Re: New Canaan Teen Center – Structural Survey
77 Main Street
New Canaan, CT 06840
TDEG Project No. 16153.00

Summary of Conditions Observed:

No. 8

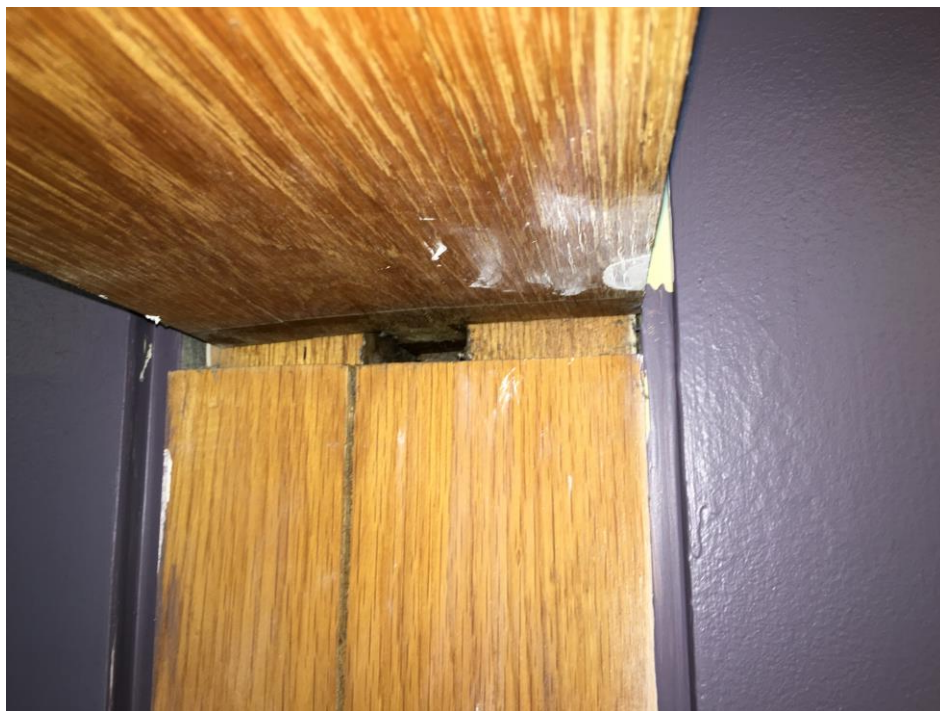
6. The nailing for the flooring/ decking has pulled out of the joists at locations. No readily apparent reason. **See Photo No. 8**
 7. Foundation wall on west side retains approximately 4 feet of fill above the floor slab. If not installed as a cantilever retaining wall having a reinforced wall and footing, and the footing wider than is normally used there may be some lateral soil pressure exerted on the framed structure
